# City of Santa Fe, New Mexico

# memo

2025-010497-HDRB, 964 Acequia Madre, Downtown and Eastside Historic District, Contributing, Manuel Mendoza, agent for Anjani Thomas, owner, requests to replace roofing material to a 26-gauge sloped metal roof color natural galvanized steel and requests exceptions to 14-5.2(D)(1)(a) removal of historic material and 14-5.2(D)(5)(b) architectural features, finishes, and details other than doors and windows, shall be repaired rather than replaced.

**Figure 2. Current roof condition.**

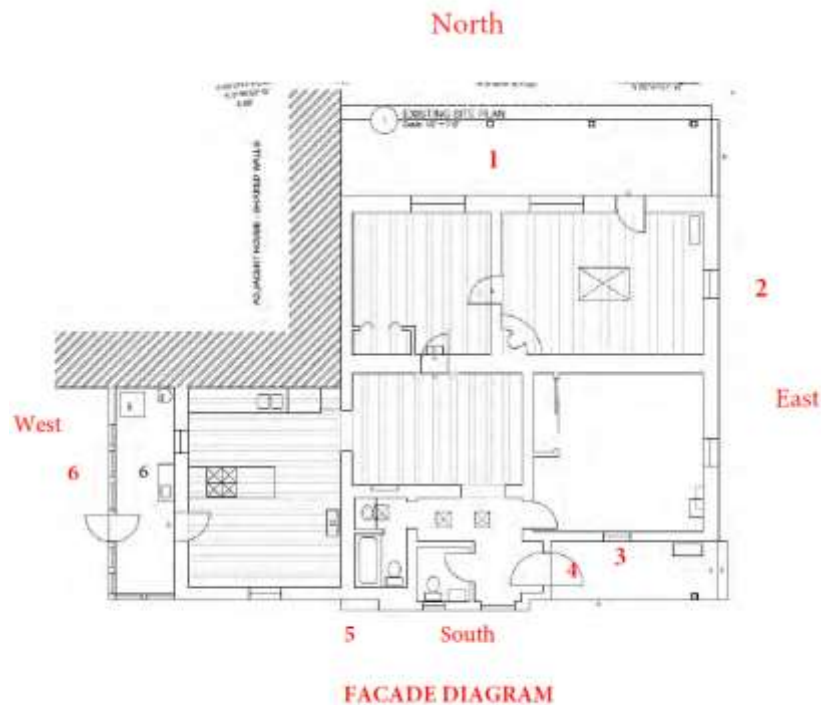
Staff Response: Staff has evaluated the applicant's response and finds that the criterion has been met. The current roof is in complete disrepair and needs to be sufficiently removed and replaced with a roofing system that will provide the structural protection needed for this contributing structure.

Staff Response: Staff has evaluated the applicant's response and finds that the criterion has been met. A new structurally sound roof would provide the necessary protection needed for preserving the contributing status of the structure and minimizing animals from living inside the current roof.
